Access Compliance Report

Public Rights-of-Way

(Curb Ramps)

| Intersection ID: 26472 | Main Street: MANNINGTON_DR | Cross Street: MCKEE_FARM_LN | Location: SE |

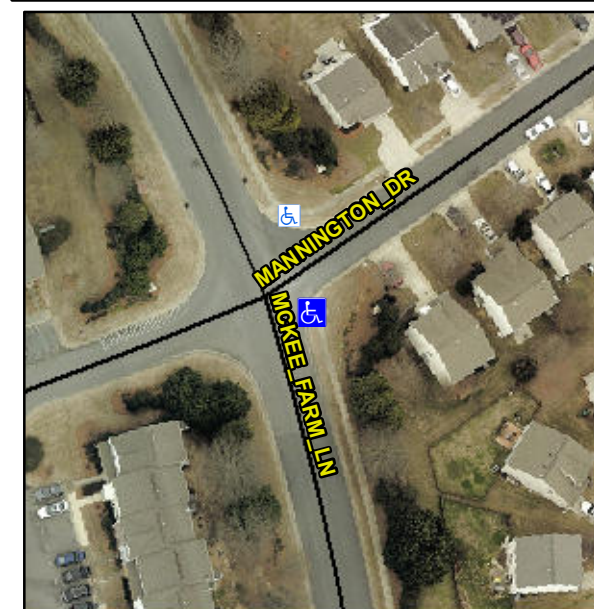
| ADA ID: C5815285FCDC | Ramp Type: Perp | Initial Pass/Fail: Pass | Overall Compliance: No |
| Codes/Mitigation Info/Possible Solution | | | Severity Score: 10 |

Not Found, R304.2.2-Perp, R304.3.2-Para, R304.5.3, R305

| Compliance | Description | Data | Compliance | Description | Data |
|------------|-----------------------|--------|------------|-----------------------------|------|
| Yes | Landing Length (in) | 50.0 | No | DWS Provided? | No |
| No | Landing Slope (%) | 7.6 | N/A | DWS Length (in) | N/A |
| No | Landing X Slope (%) | 3.1 | N/A | DWS Full Width? | No |

Possible Solutions:

Remove & Replace Entire Ramp.
